02.00 CONSENTED VS. PROPOSED DRAWINGS

Planning Application 2021/3561/P

03.00 PROPOSED AMENDMENTS 3D VIEWS
03.01 BOUNDARY WALL - PARAPET EXTENSION

02.10 WEST ELEVATION

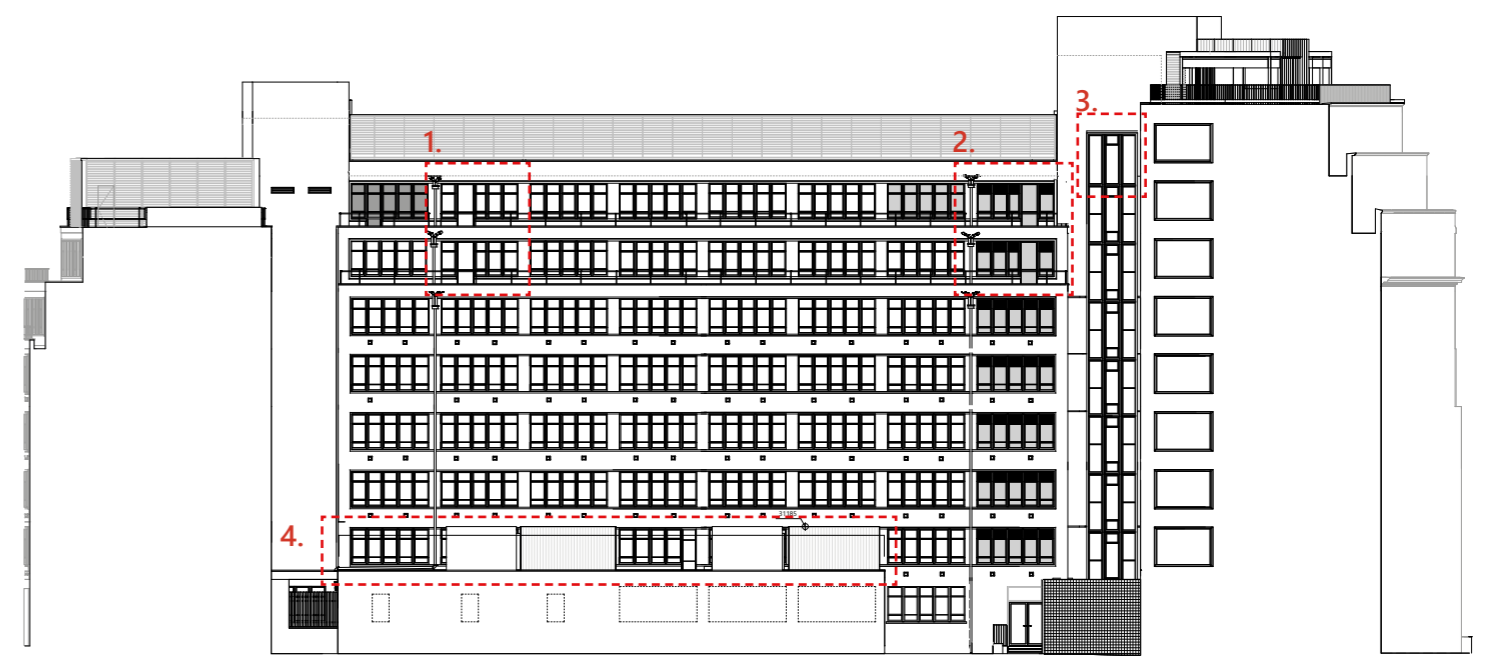
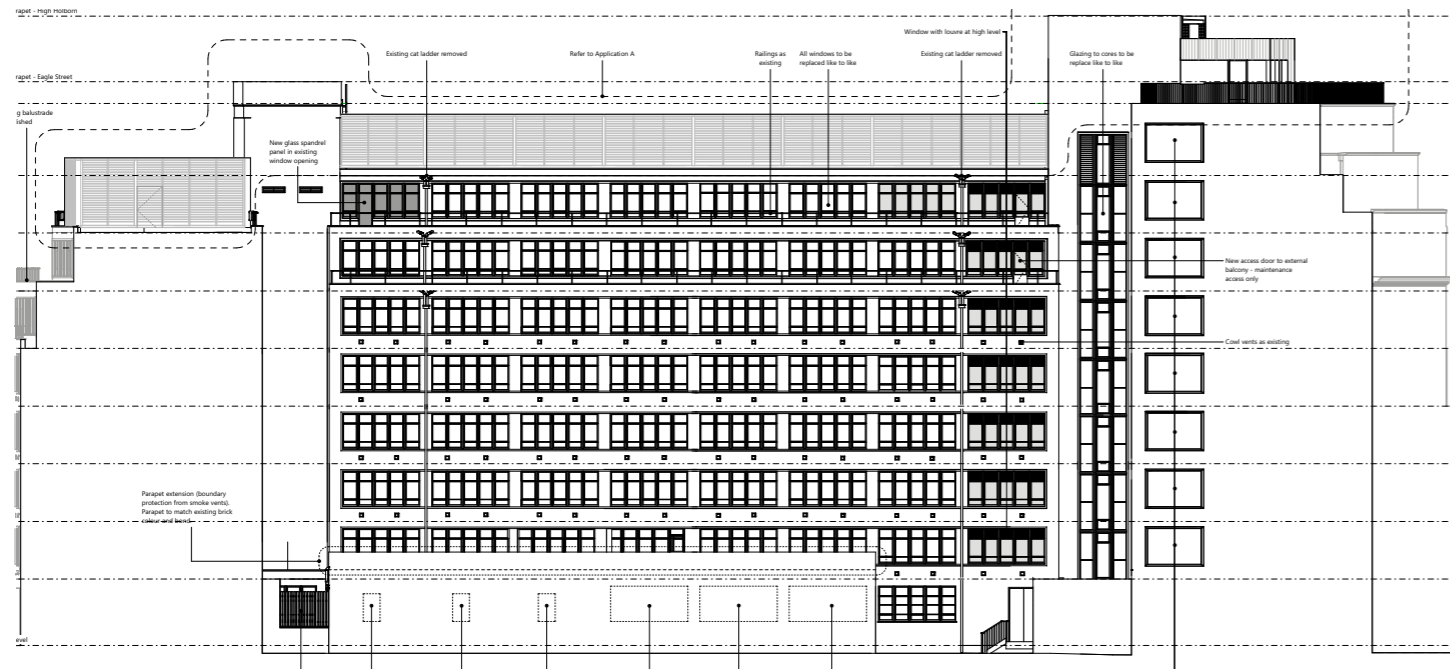
1. Full height doors to external balcony integrated within window bay.
2. Full height doors widened for external balcony access
3. Top bay of curtain wall on the cores to have glazed panes instead of glazed louvres (existing condition)

4. Boundary wall/Parapet extension to accommodate roof light increase in height. This change is so to protect the boundary condition and avoid direct discharge of smoke onto the neighbouring properties.

02.11 EAST ELEVATION

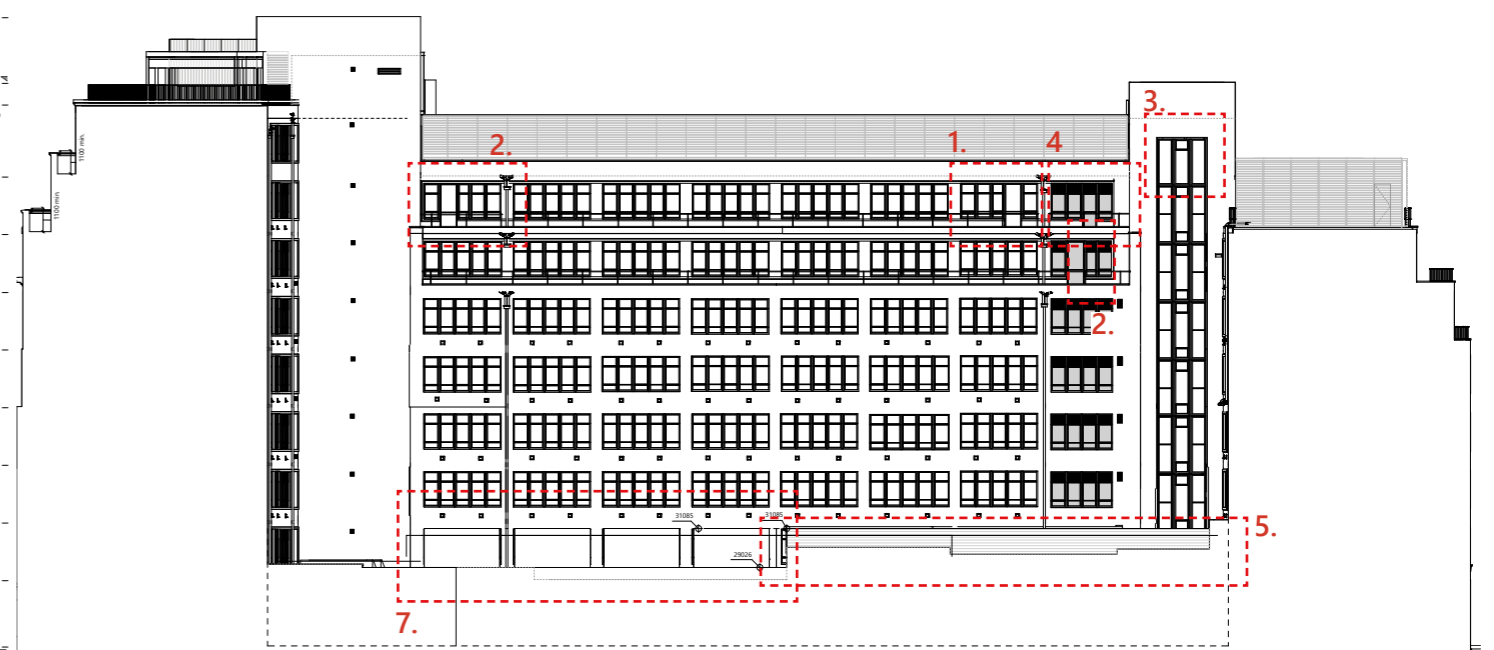
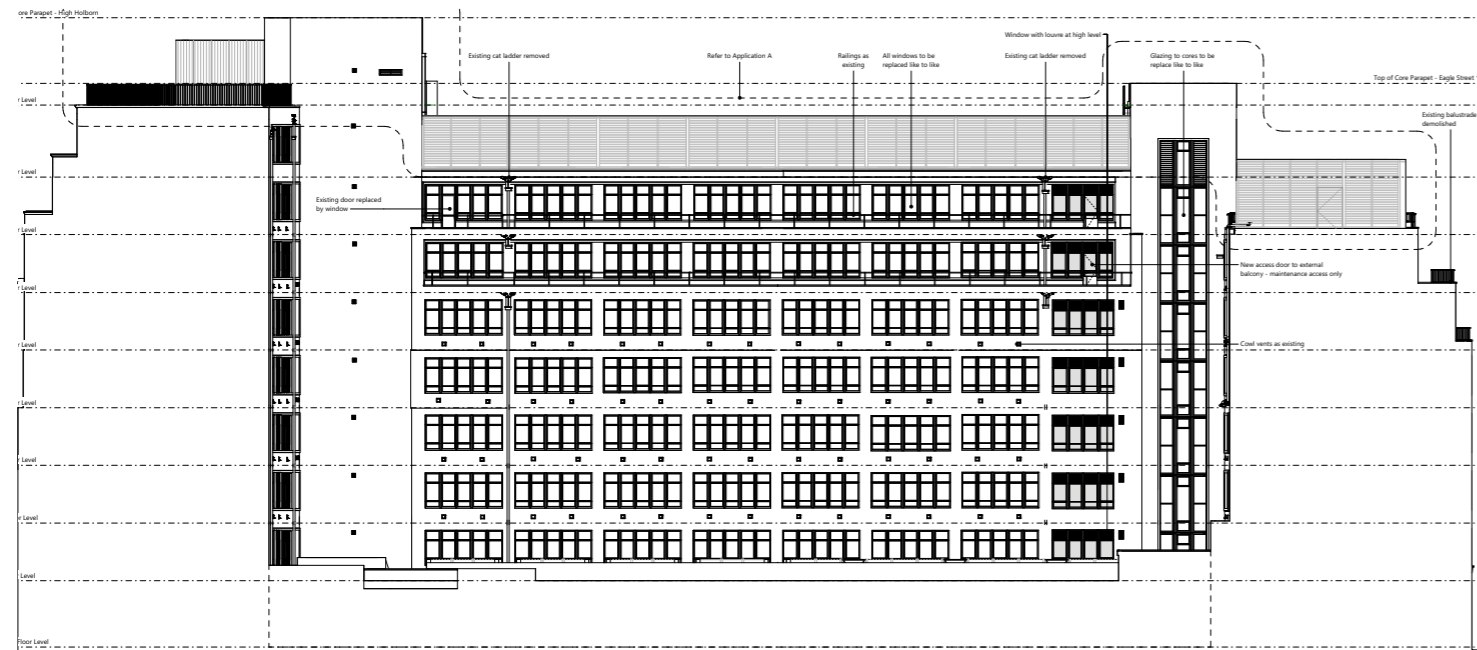
1. Access door to external balcony integrated in window bay.
2. Window bay configuration amended - access door height and width amended
3. Top bay of curtain wall on the cores to have glazed panes instead of glazed louvres (existing condition)

4. Fixed window panel where door existing access to external balcony is.
5. Boundary wall/Parapet extension to accommodate roof light increase in height. This change is so to protect the boundary condition and avoid direct discharge of smoke onto the neighbouring properties.

6. Roof lights height and slope amended to accommodate changes following London's fire brigade feedback on the scheme. The smoke venting provision for the lower ground floor had to be revised and the number of vents required increased significantly. In order to accommodate this change the vents were omitted from the glazed roof and moved to the vertical up-stand of the roof lights, as the glazed system has proven to be unable to deliver the required free area for smoke venting.

02.12 HIGH HOLBORN NORTH ELEVATION

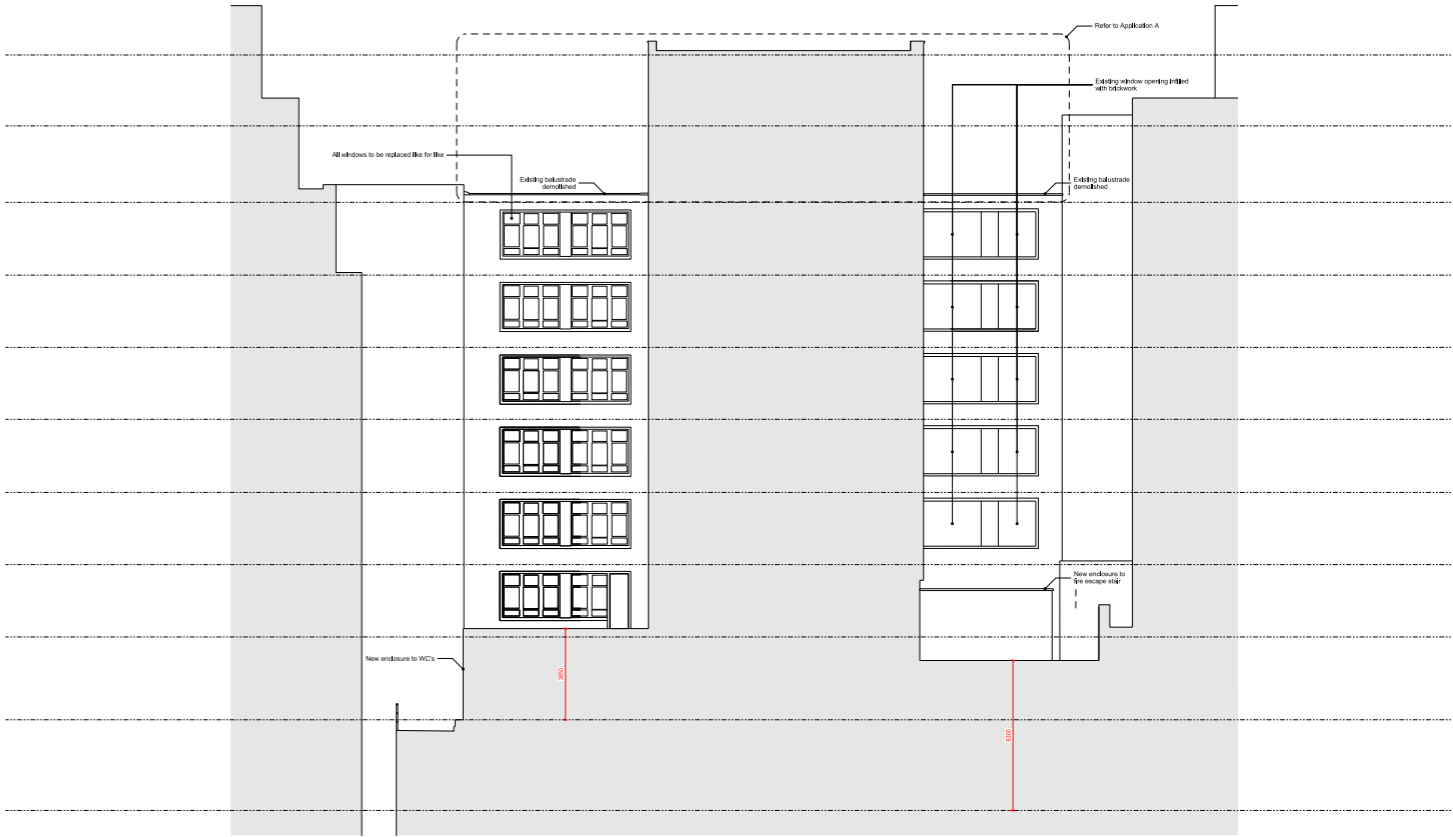
1. Boundary wall/Parapet extension to accommodate roof light increase in height. This change is so to protect the boundary condition and avoid direct discharge of smoke onto the neighbouring properties.
2. Roof lights height and slope amended to accommodate changes following London's fire brigade feedback on the scheme. The smoke venting provision for the lower ground floor had to be revised and the number of vents required increased significantly. In order to accommodate this change the vents were omitted from the glazed roof and moved to the vertical up-stand of the roof lights, as the glazed system has proven to be unable to deliver the required free area for smoke venting.

02.12 HIGH HOLBORN NORTH ELEVATION

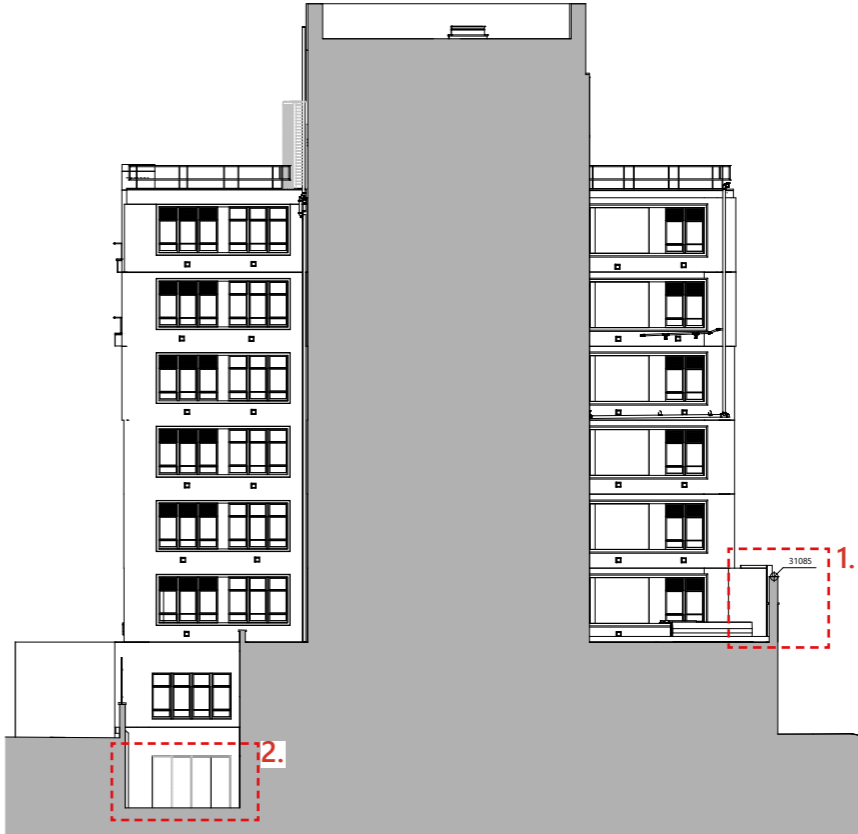
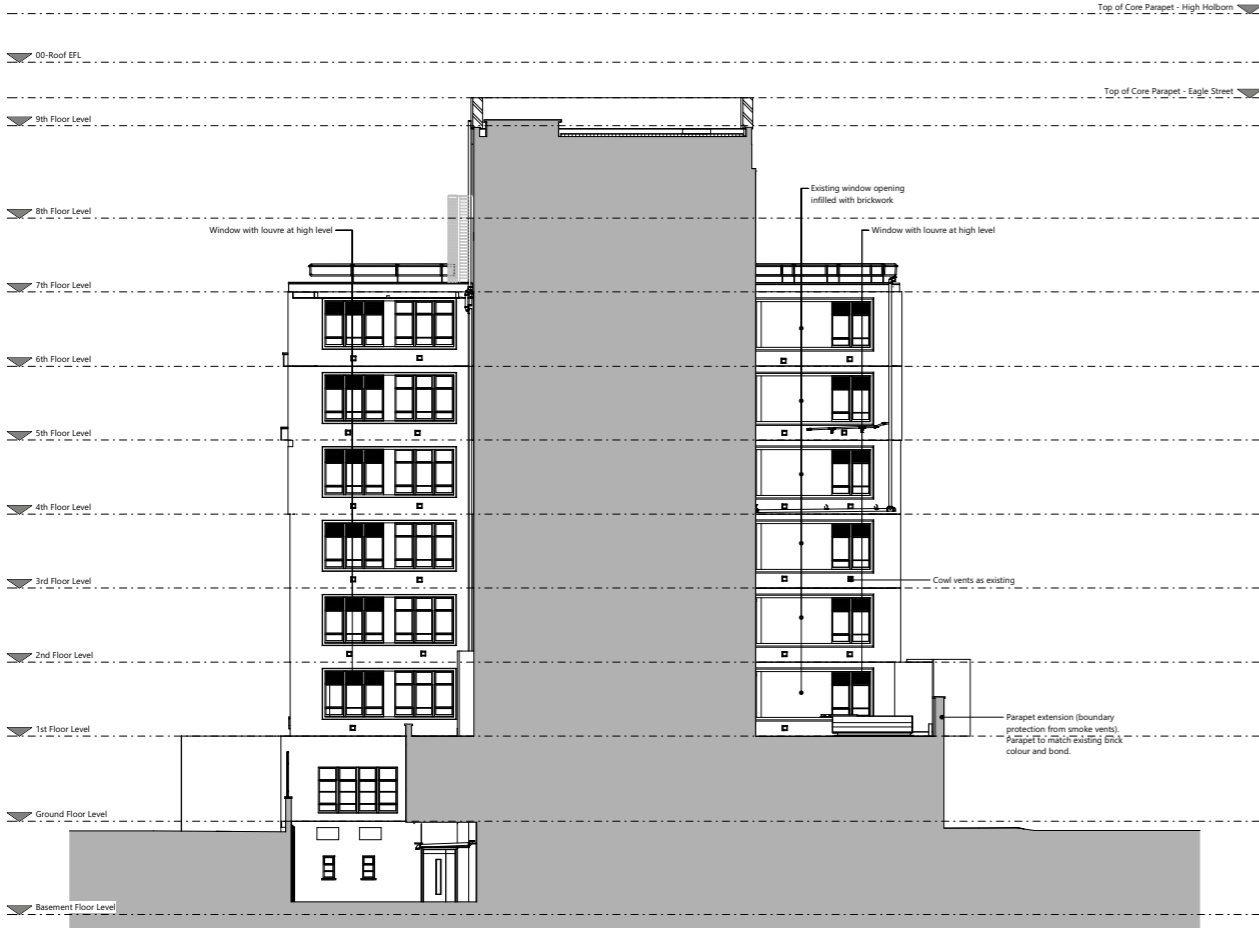
- 1. Boundary wall/Parapet extension to accommodate roof light increase in height. This change is so to protect the boundary condition and avoid direct discharge of smoke onto the neighbouring properties.

- 2. Smoke vents required following consultation with London Fire Brigade.
